**REGULAR MEETING OF THE  
CITY OF CONCORD  
DESIGN REVIEW BOARD**

**Thursday, May 26, 2016  
5:30 p.m., Regular Meeting  
PERMIT CENTER CONFERENCE ROOM  
1950 Parkside Drive, Bldg. D**

**REPORT TO DESIGN REVIEW BOARD**

**Project Name:** Burger King Restaurant (PL 16098 DR)  
**Review Status:** Final Design Review  
**Location:** 5450 Ygnacio Valley Road  
**Parcel Number:** APN 120-270-066  
**General Plan:** Neighborhood Commercial  
**Zoning:** NC (Neighborhood Commercial)  
**Applicant:** Amir Sahebalzamany  
2821 Crow Canyon Road, Suite 202  
San Ramon, CA 94583  
(925) 552-9377

Proposed - Exterior Elevations

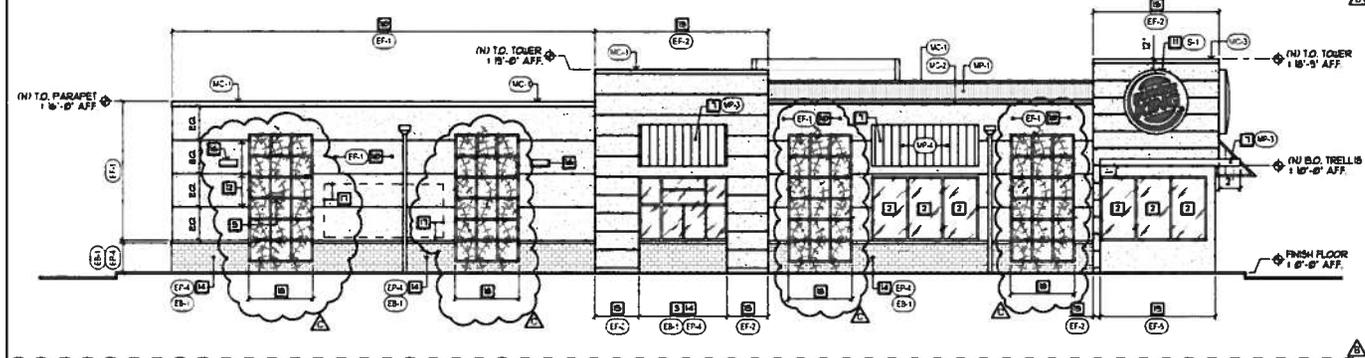
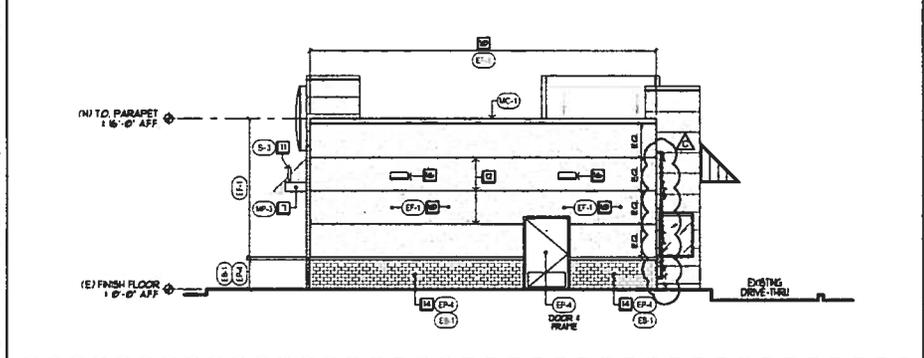
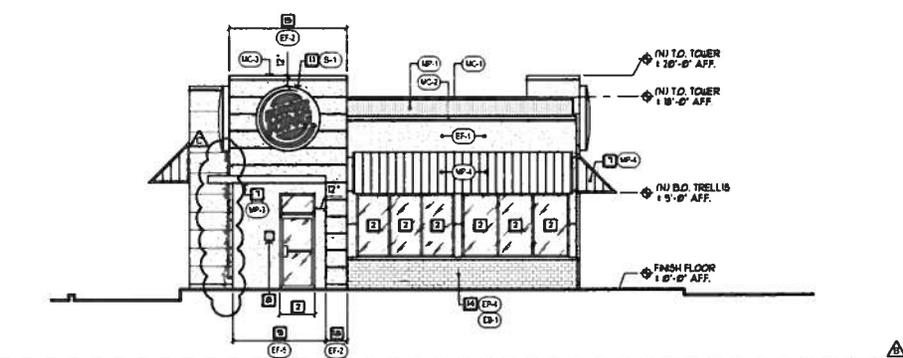
**The applicant proposes to move forward with a four-sided design concept, and therefore the revised architectural plans reflect the removal of the existing awning that was shown at preliminary design review on the rear and right elevations. The architect has added a new tower element at the drive-thru window. The elevations now have a flat wall that extends to the top of the building, finished with a narrow wall cap. Both walls are now designed with a stucco finish. The windows on the rear elevation have new aluminum awnings above each window. In addition, the rear elevation now incorporates trellis features to add interest to the façade.**

**In addition, the revised elevations have incorporated new aluminum awnings on the front and left side elevations, and incorporated stucco finish on the upper walls. A circular Burger King sign has been added to the rear elevation at the corner tower and removed from the right side elevation (above the rear door).**

The applicant responded to the Board's recommendation. Staff supports the applicant's redesign of the project that removes the existing awnings that were previously included on the rear and right elevations. However, there are some design elements that have been removed through the redesign that staff would like to see returned to the project; this includes the brick wainscot at the entries (as highlighted below in #2). Staff supports the addition of the trellis features on the rear of the building that have been added. Staff does not support the use of wall pack lighting which typically appears very industrial.

- Staff recommends the entry towers be modified to re-incorporate the brick wainscot that was shown on either side of the entry on the previous plans.

**CONCEPTUAL LANDSCAPE RENOVATION PLAN**

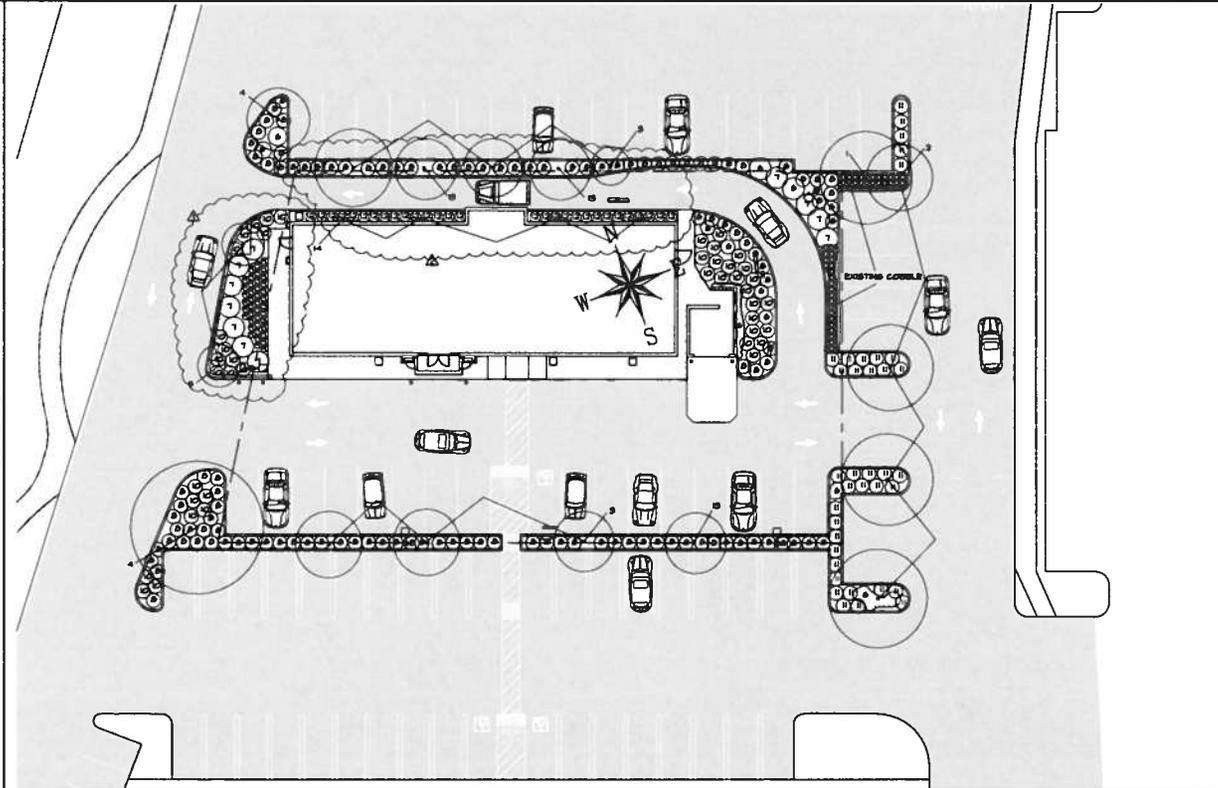
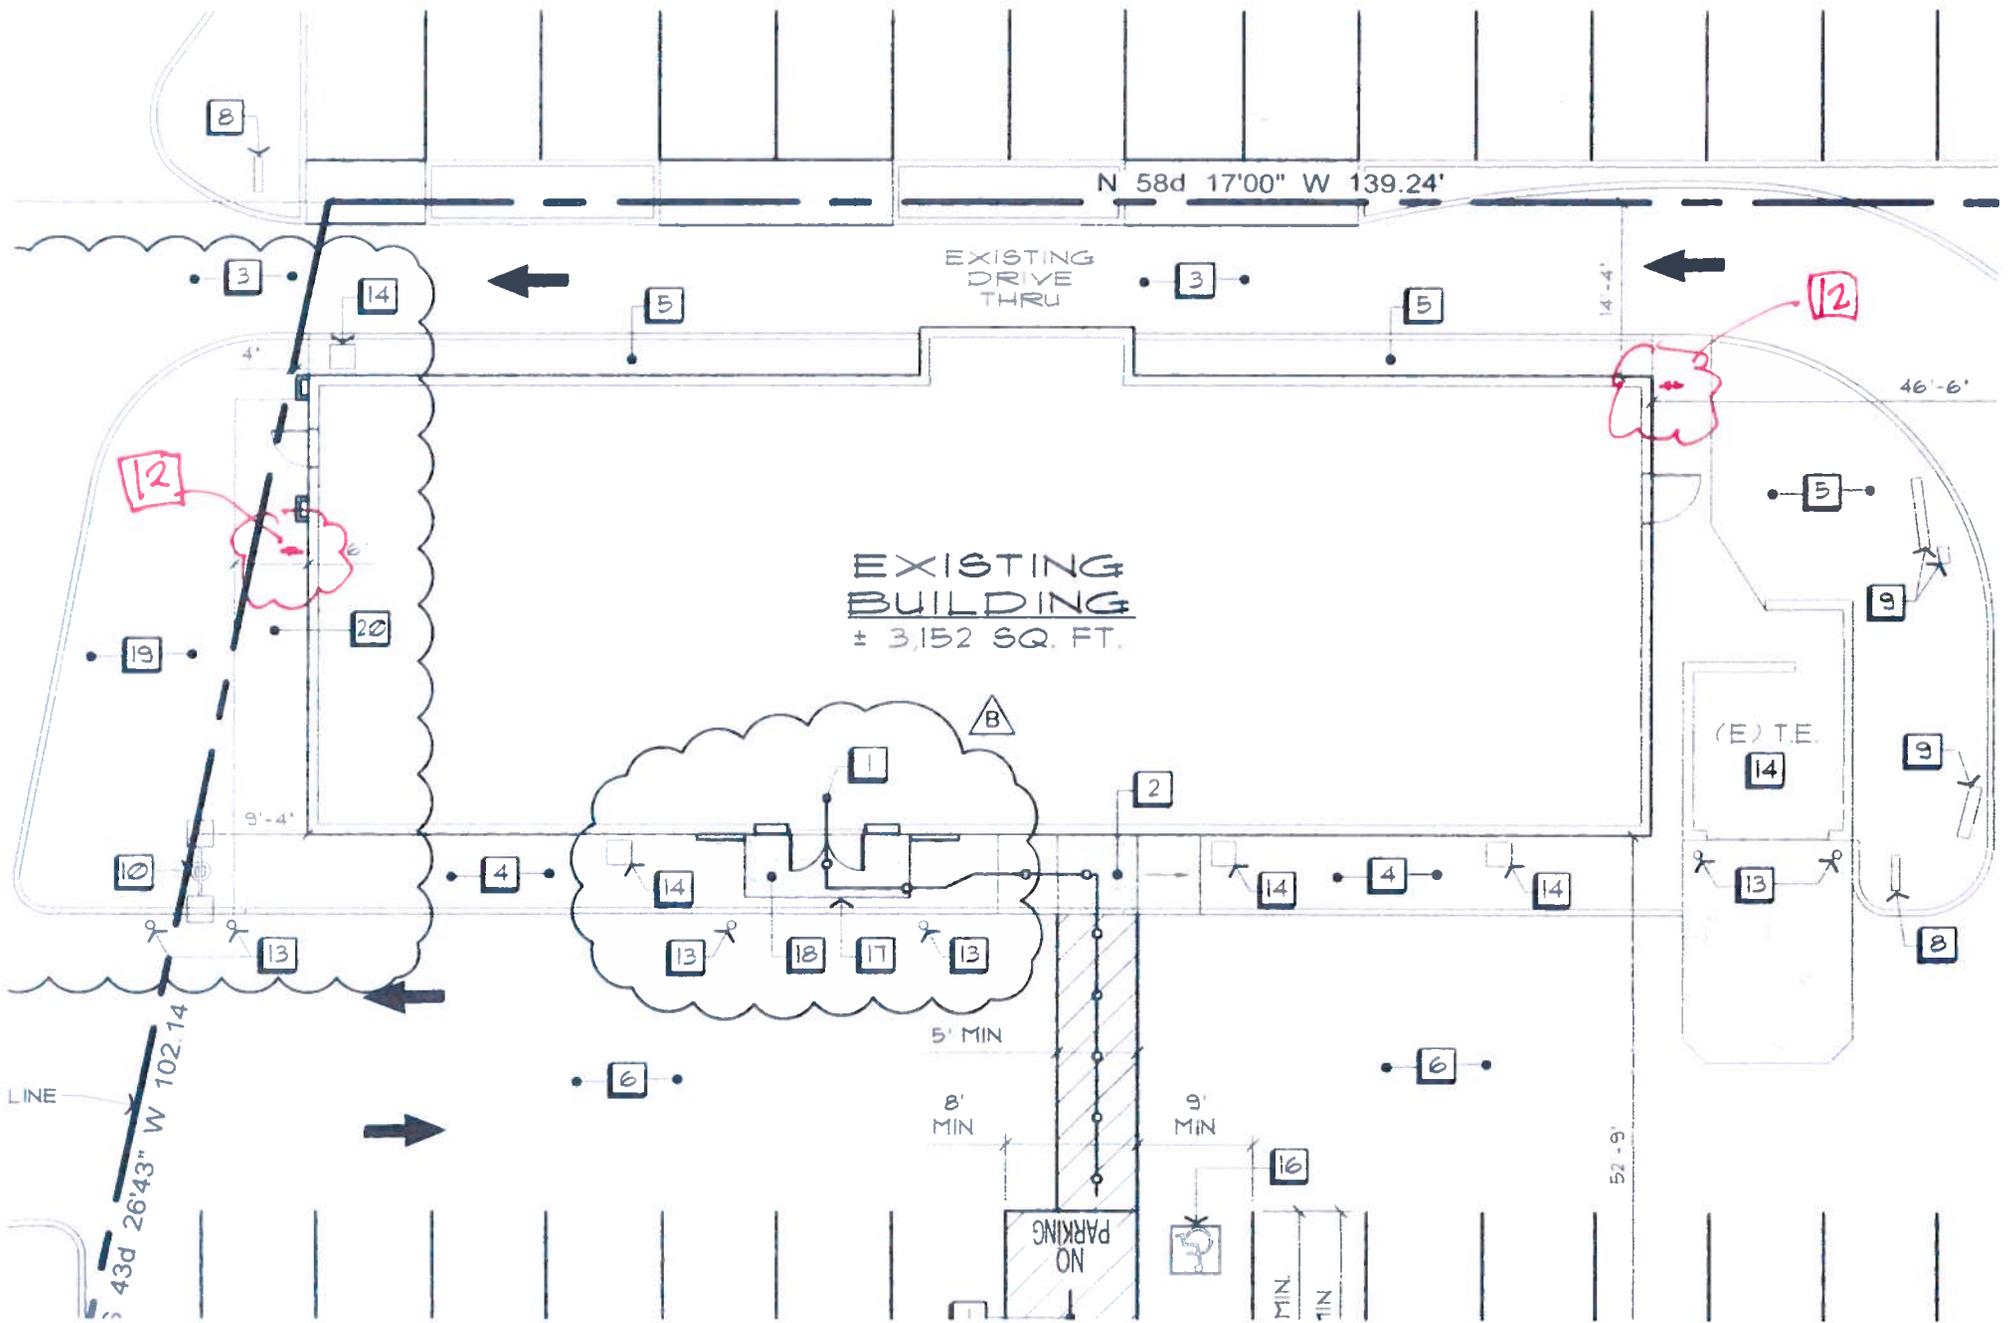
- 6) *Add planting areas where the outdoor patio is currently located and remove tables, extending planting near exit door (left side elevation) to discourage pedestrians from walking across drive-thru lane from parking area to the north; incorporate bike rack.*

- 7) *Continue planting along right side of drive-thru lane and install green screen with vines.*

**The architect has submitted revised landscape plans that provide a new planting area where the outdoor patio was previously located. The planting area provides a walkway adjacent to the exit door on the left elevation. The planting (Xylosma) extends to the right of the exit door to discourage pedestrians from walking across the drive-through lane. In addition, the applicant has submitted a supplement to the site plan (redlined) indicating where they are locating a bike rack adjacent to the exit door on the left elevation and adjacent to the exit door on the right elevation. The architect has also forwarded a bike rack detail for the project.**

**The architect has submitted revised landscape plans that provide a new planting area extended along the right side of the drive-thru connecting the existing planting areas. Southern magnolias (15 gallon) and Coral Cotoneaster (1 gallon) are proposed. Green screens are not shown on the plans.**

- The applicant responded to the Board's recommendation. Green screens were not included however, but staff believes the incorporation of the new planting area at the(former) patio should be sufficient to discourage customers from parking on the north side to access the restaurant.

**(N) CEMENT PLASTER TERMINATION**

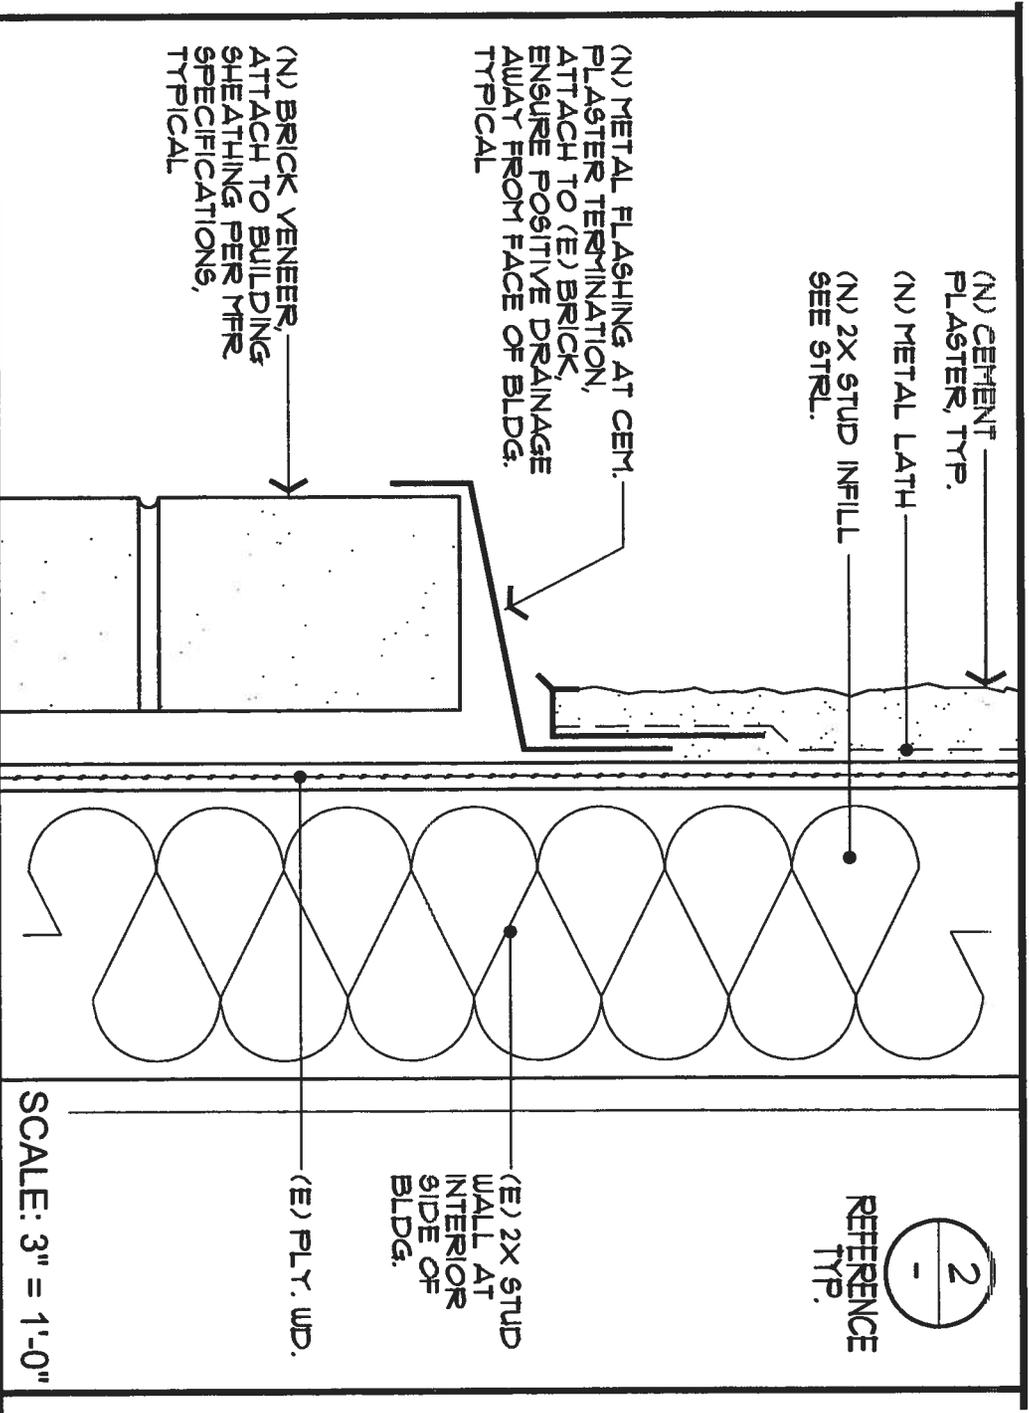
**The applicant has provided a detail, "Detail 9" included within the revised plan set (Exhibit A) showing the proposed metal flashing between the brick wainscot and the upper stucco finish that will be accomplished with a metal screed.**
